CITY OF OREGON CITY

PLANNING COMMISSION

FILE NO.: ZC 04-02

REQUEST: Zone Change from "R-10" Single-Family to "R-8" Single-Family.

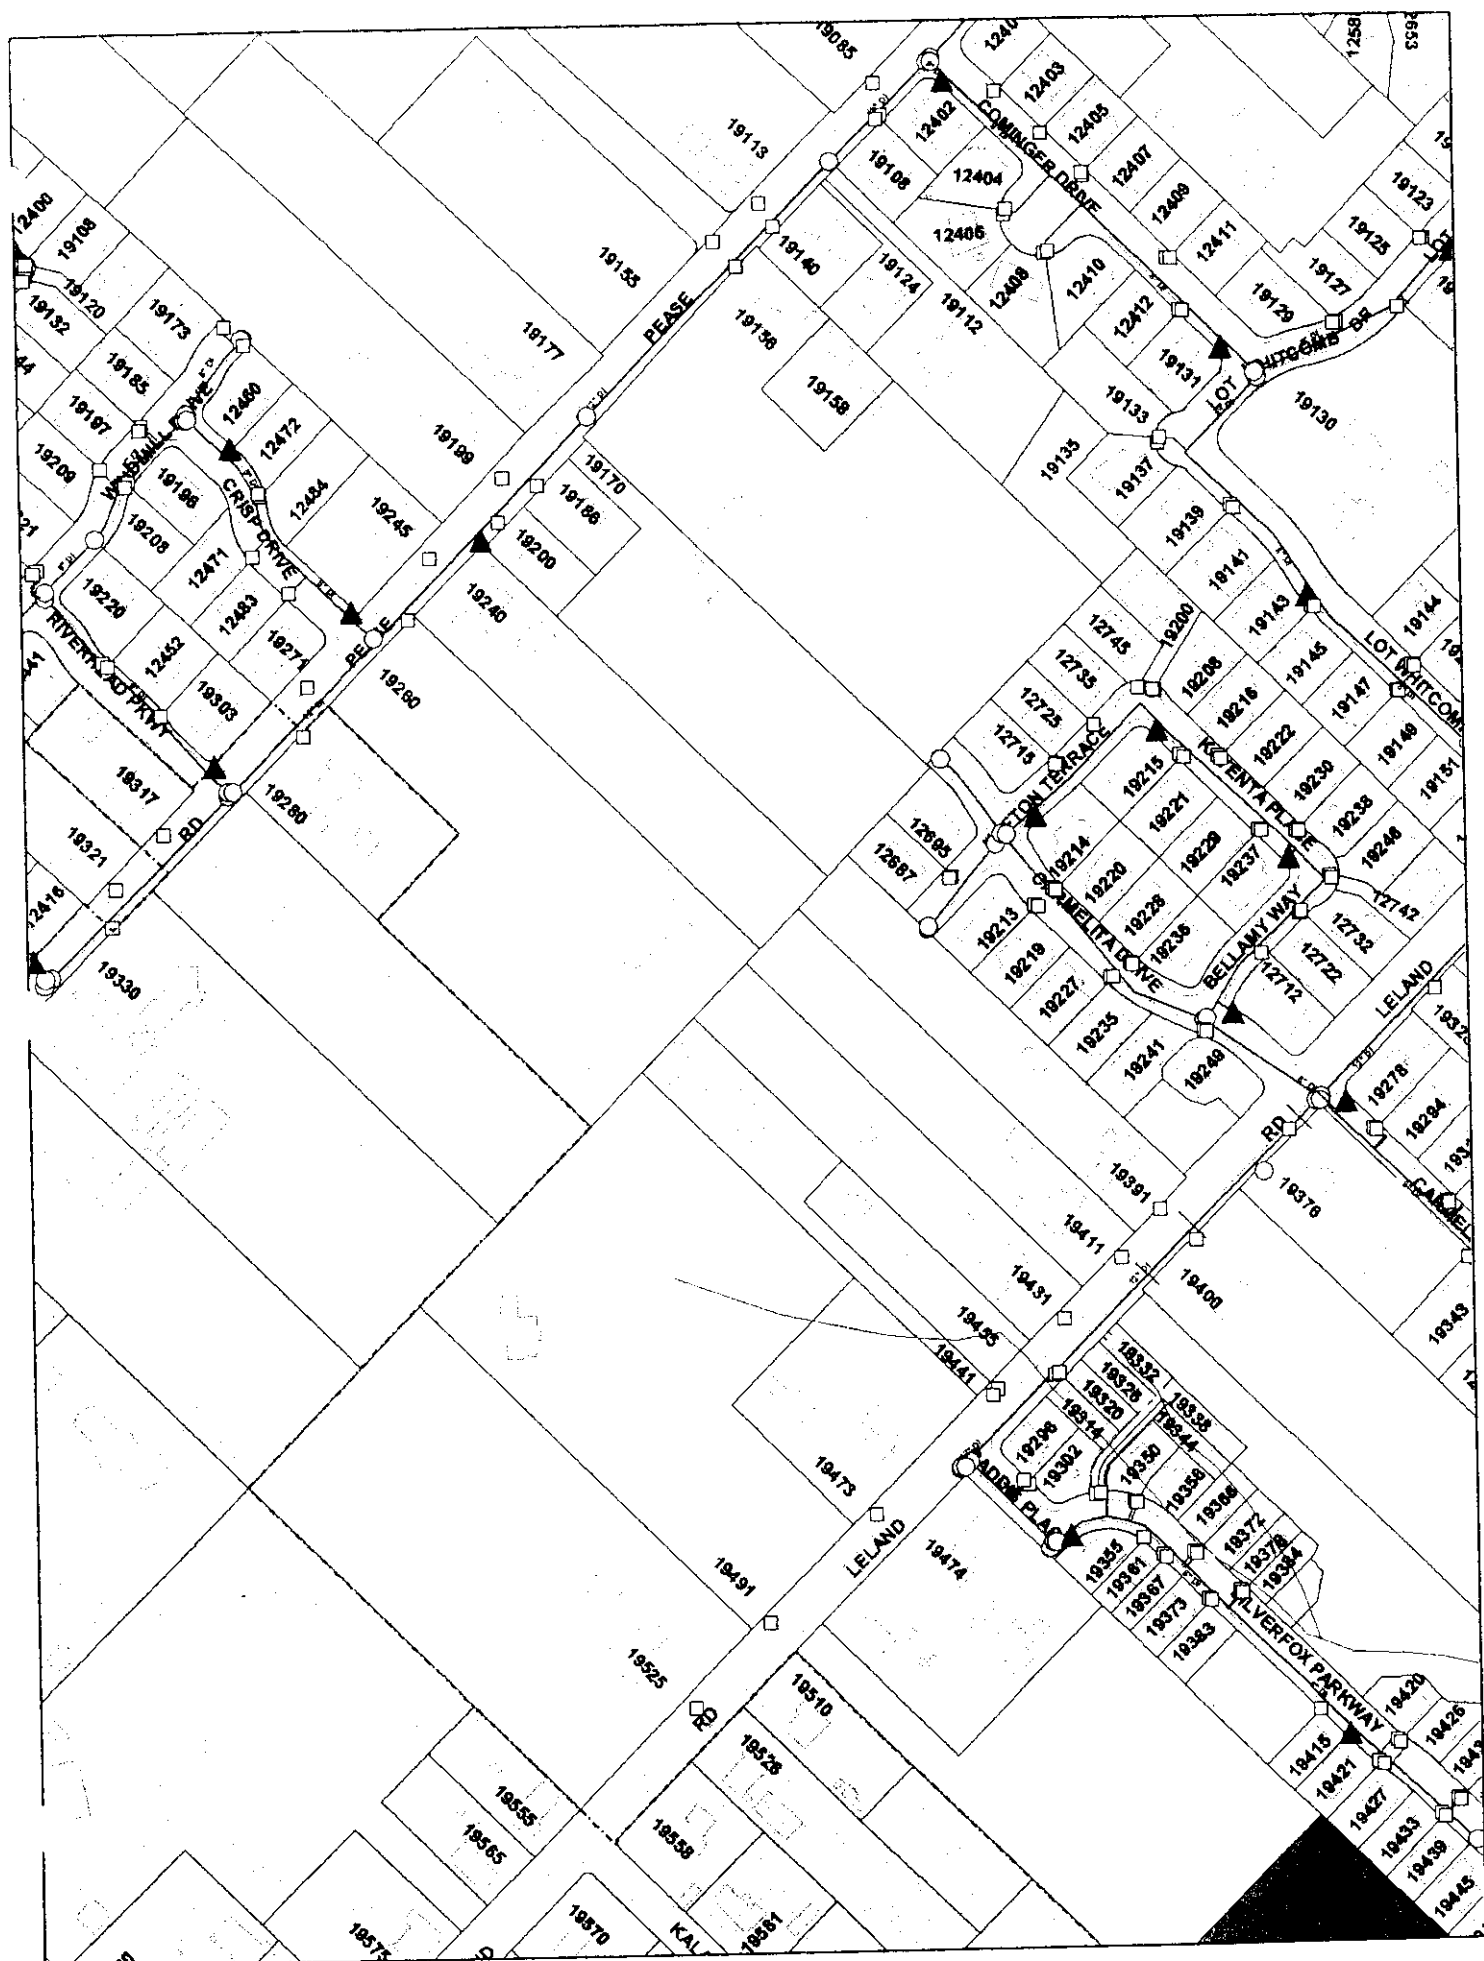
Consult Water Master Plan. Comments are made on preliminary plan sheet # 3: For improved fire flow, water quality and circulation connect proposed H2O main from Pease, thru subdivision and connect to Leland Road. Realign proposed H2O main so service lines to lots # 26 & 27 are shorter. Confirm that lots # 22, 23 & 24 are copper services & on OC H2O main, if not, switch to OC's 12" main. Cut & cap old service line at existing H2O main & switch to new main for lot # 10. Avoid the long dead-end mains for lots # 5 & 13; No service line shown for lot # 14. See sheet # 3 for red-lined details. See attached OC water map.
